# CONNECTICUT YANKEE ATOMIC POWER COMPANY

Haddam Neck Plant  
Update of License Termination Plan

**Update of License Termination Plan  
Revision 6**

**Attachment 1  
Haddam Neck Plant  
License Termination Plan, Revision 6  
Summary of Changes**

| MAP #:                 | FIGURE 2-2 |

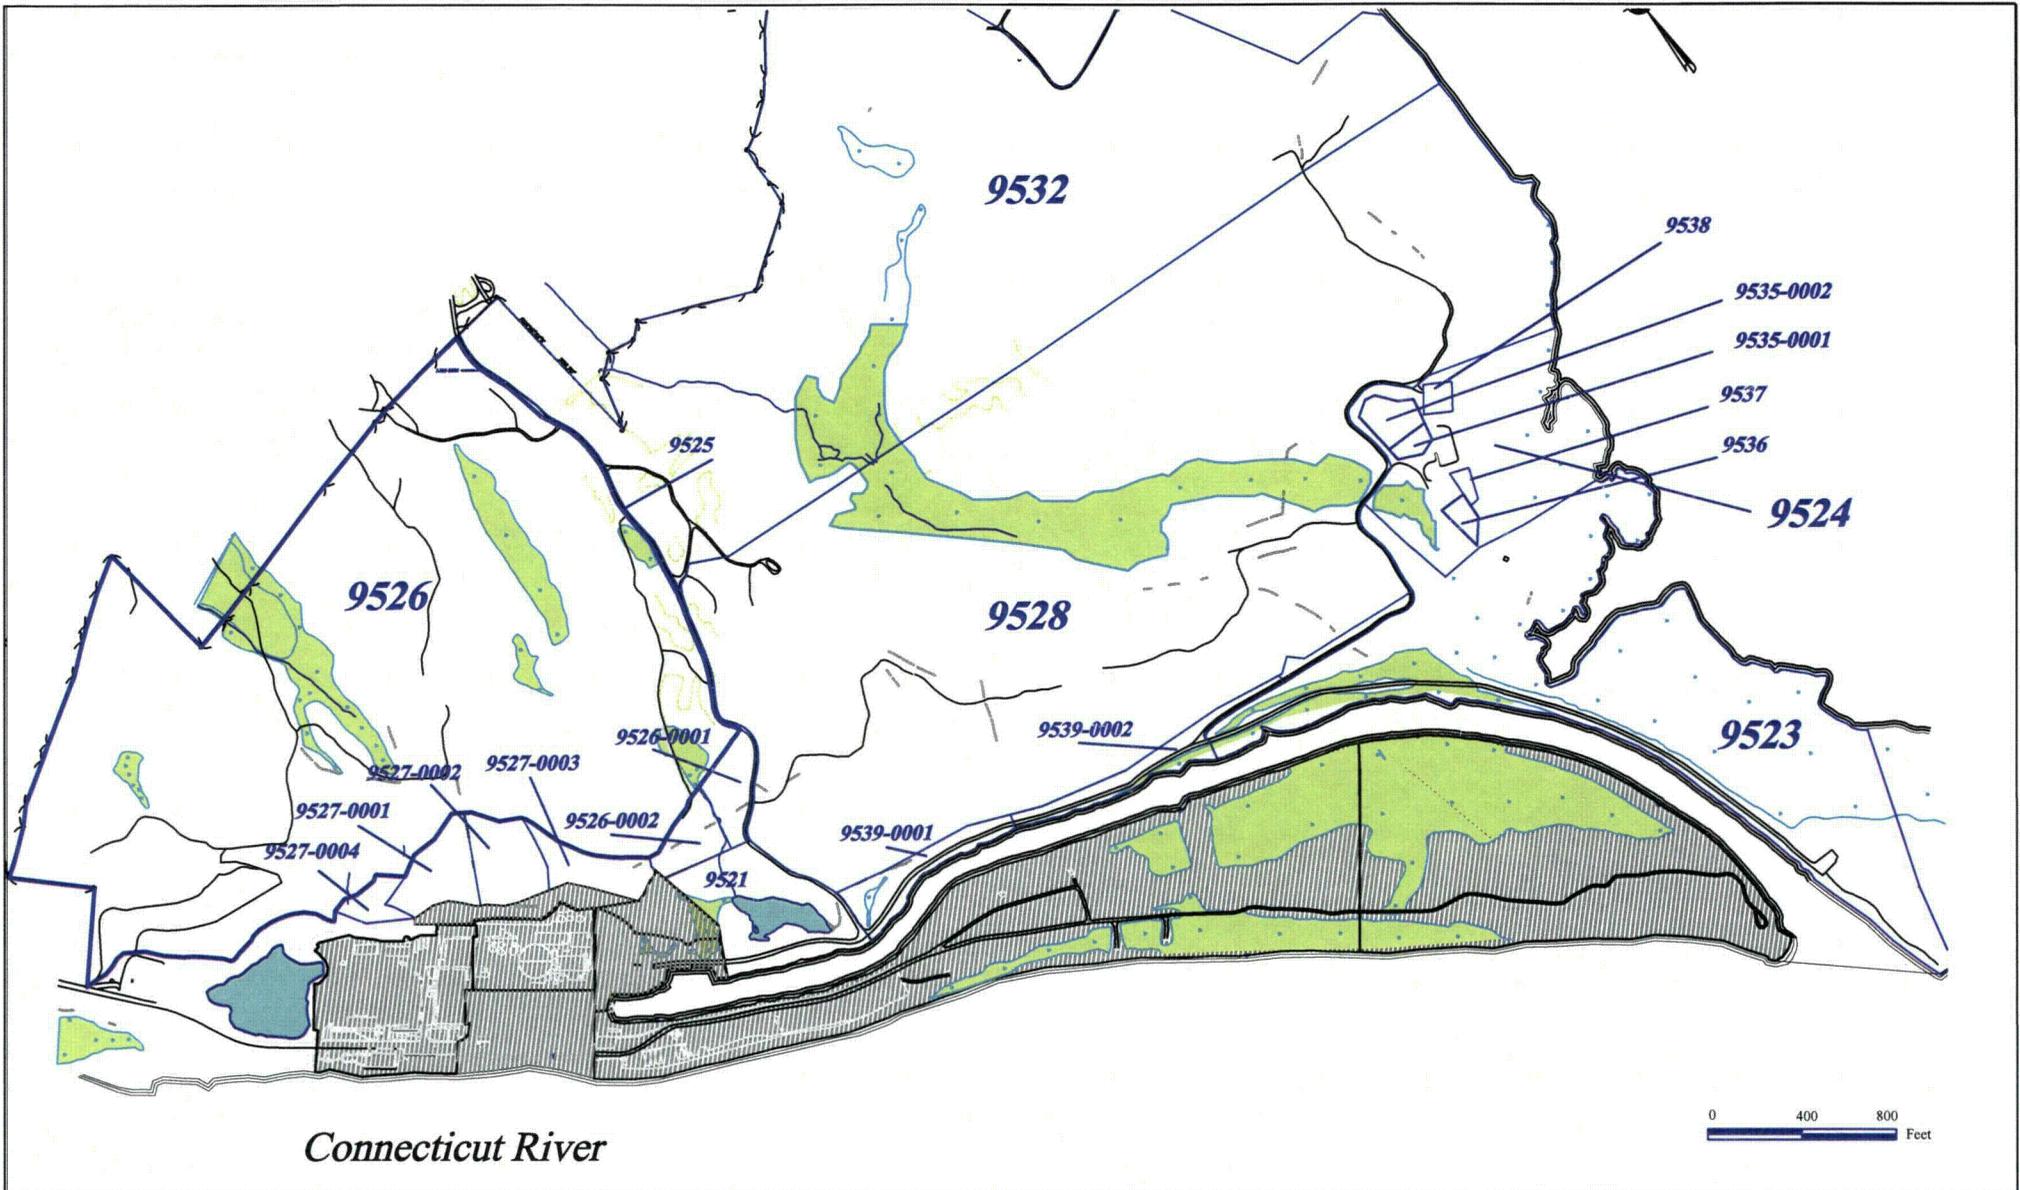
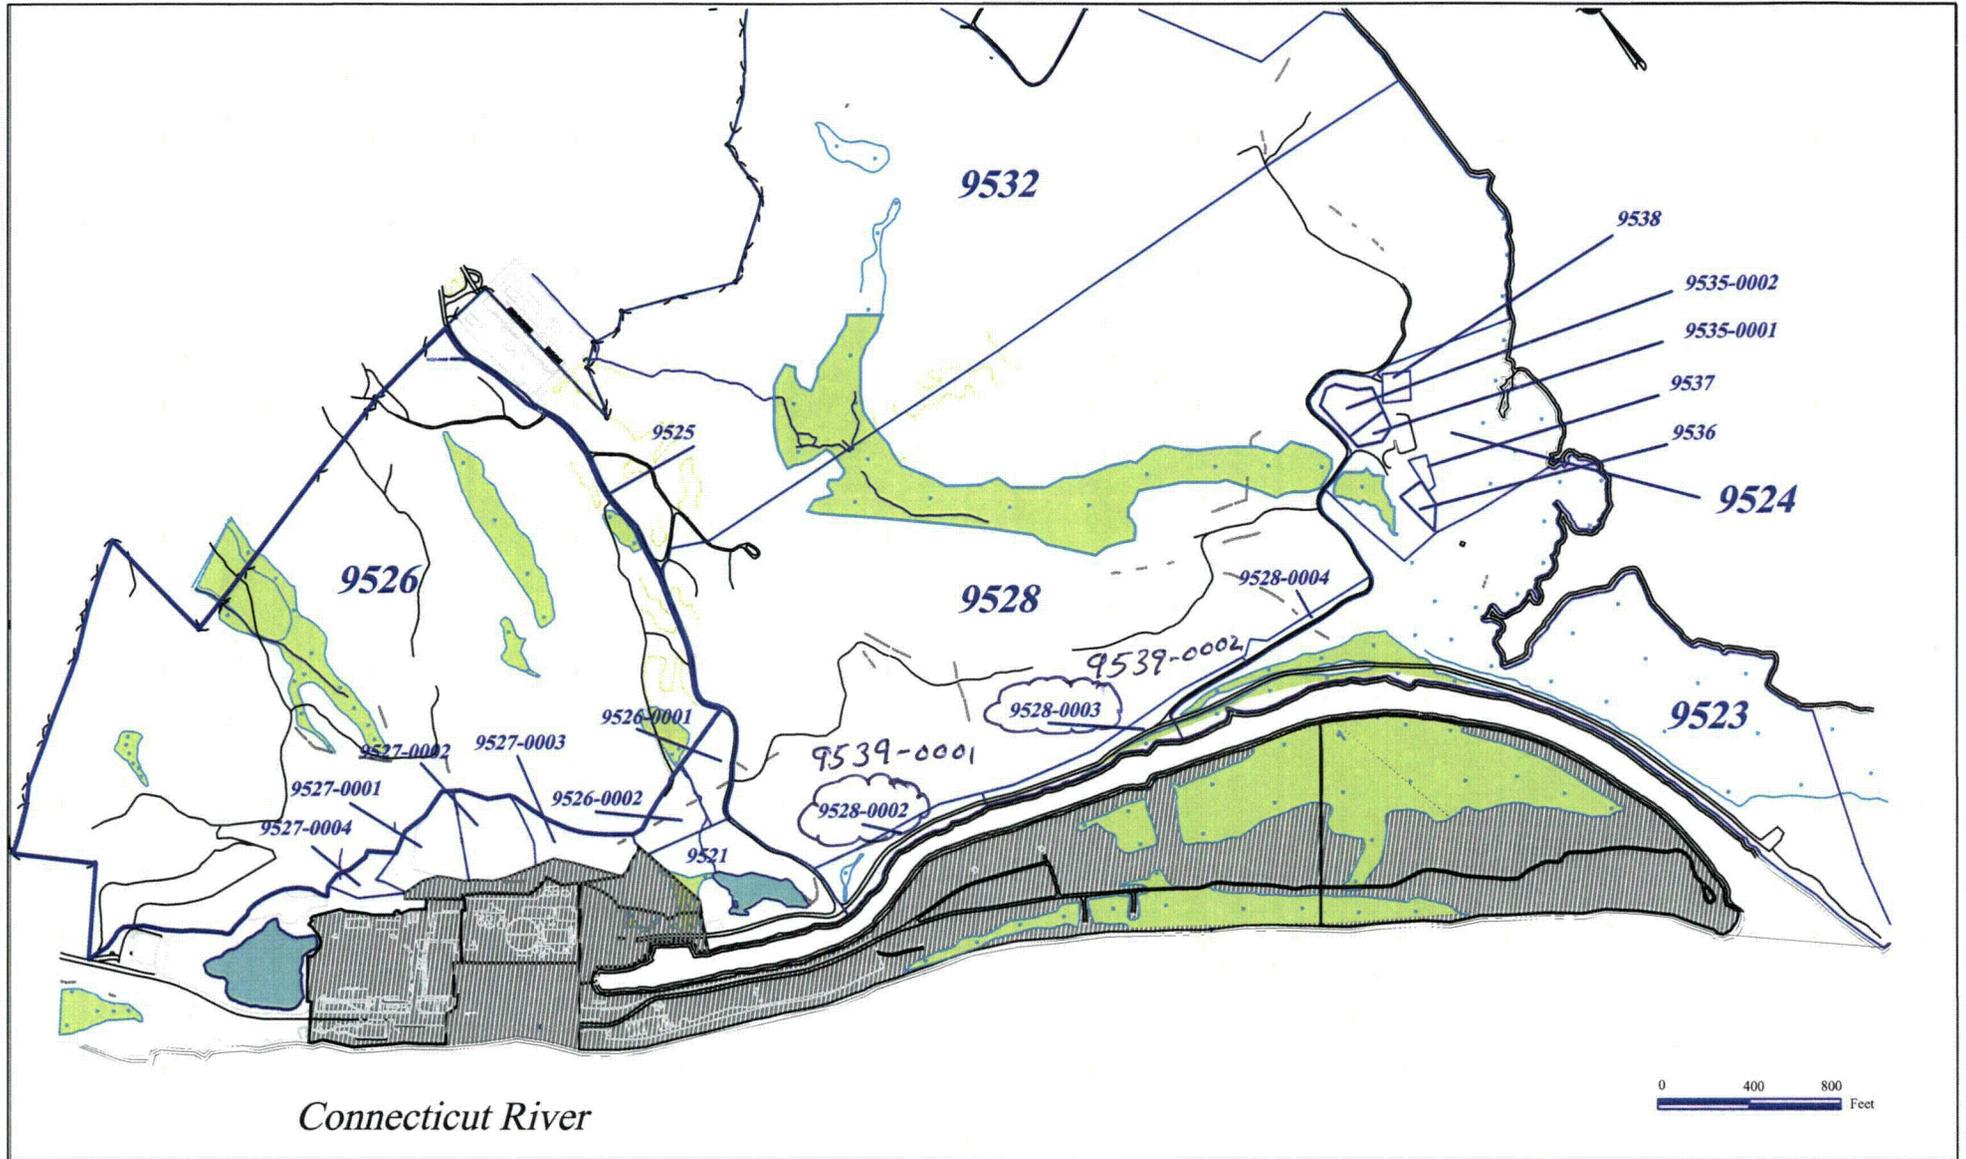
| <b>Item No.</b> | <b>LTP Page or Section</b> | <b>Description of Change</b>  | <b>Reason for Change</b>   | <b>Downgrade in Commitment</b> |
|-----------------|----------------------------|---|--|--------------------------------|
| 9               | Figure 2-2                 | Add Survey area 9520-0006 a class 1 survey unit.  | Made 9520-0006 Class 1 survey unit from 9520-0001 a class 2 survey unit. During a surveillance elevated activity was identified requiring remediation which requires a change in the survey unit classification. | No                             |

ADD  
SURVEY Unit  
9520-0006
